PLANNING SCHEME AMENDMENT GC28 - DONNYBROOK / WOODSTOCK PRECINCT STRUCTURE PLAN

**Mitchell Shire draft submission to Amendment
GC28 - Donnybrook / Woodstock Precinct
Structure Plan**

Submission on behalf of
Mitchell Shire Council

Appendix 2: Recommended Merristock Urban Structure

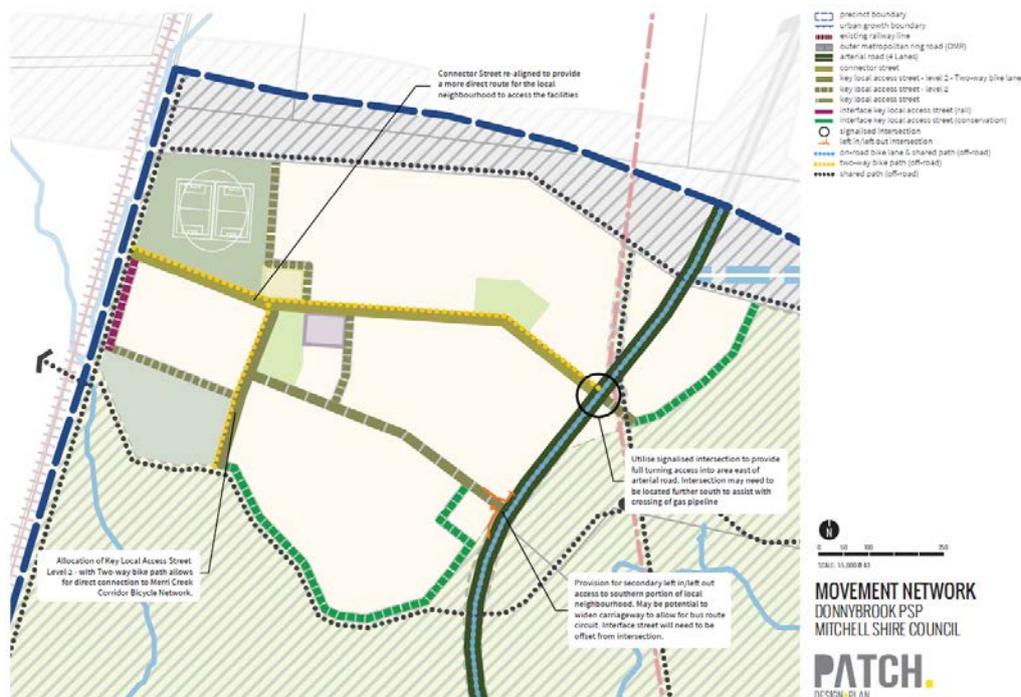
It is considered that the Merristock Local Centre Urban Design Framework could be redesigned to create a more integrated local centre as discussed above. Appendix 2 & 4 provide a recommended Urban Design Framework (UDF) for the Merristock Local Centre. It is recommended that this UDF be adopted as part of the final PSP.

The provision of a single sports ground is considered adequate to meet the needs of the subject community subject to consistency with the changes proposed as part of the UDF contained in Appendix 2 & 4.

- The future urban structure and street network plans be updated to ensure consistency with Appendices 2 and 3.
- The Urban Design Framework (UDF) for the Merristock Local Centre be replaced with the recommended version contained in Appendix 4. The future urban structure be updated to align with the amended UDF.

Appendix 3: Recommended Merristock Street Network

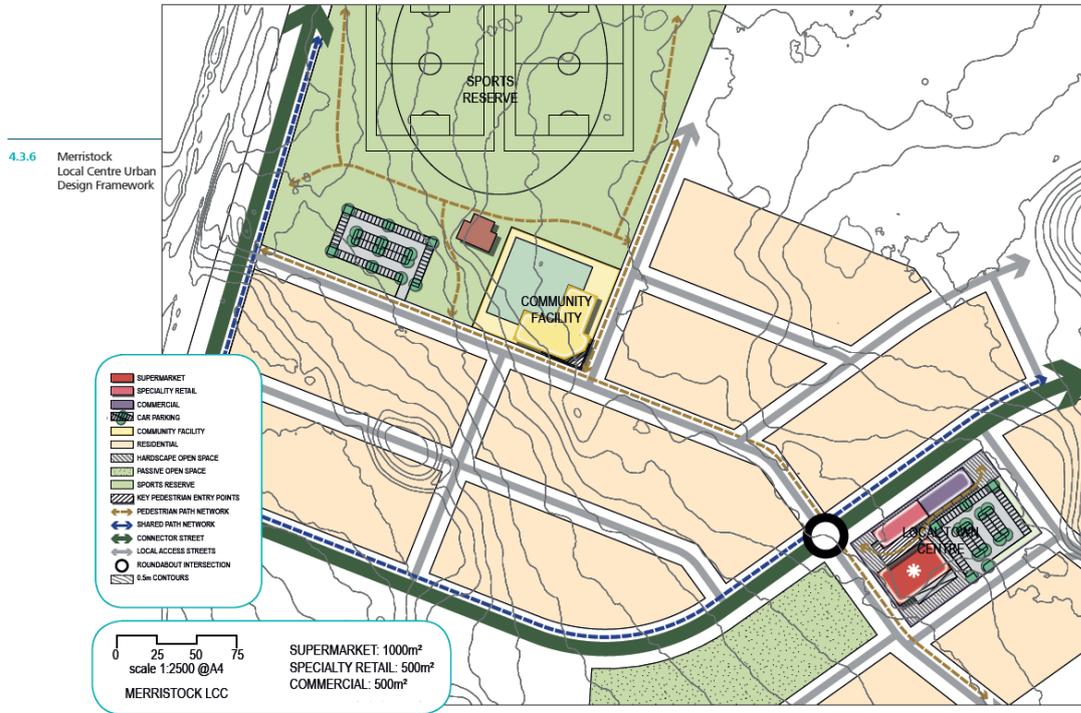
Mitchell Shire proposes the following amendments to the exhibited street network plan

- Realign the connector street to connect directly with the local convenience centre and other facilities including the community centre and active open recreation.

- Provision of a north-south running local access street with two way bike paths connecting the local convenience centre/facilities with the conservation area along the Merri Creek and the Merri Creek bicycle network.
- Utilise intersection with Pattersons Drive and connector street to provide access to pocket of residential land located east of Pattersons Drive
- Provision of secondary left in / left out access on Pattersons Drive to access southern portion of Merristock
- Realignment of interface roads to avoid intersection with Pattersons Drive.

The recommended street network plan incorporating the above amendments is attached in Appendix 3.

There is an existing underpass beneath the Melbourne – Sydney Railway which a drainage line flows through and provides access for the property owner. This existing underpass should be investigated as a potential link. The link should be included as an ICP item and the cost shared across the entire PSP as it would benefit the wider precinct. The proposed link is attached in Appendix 3.
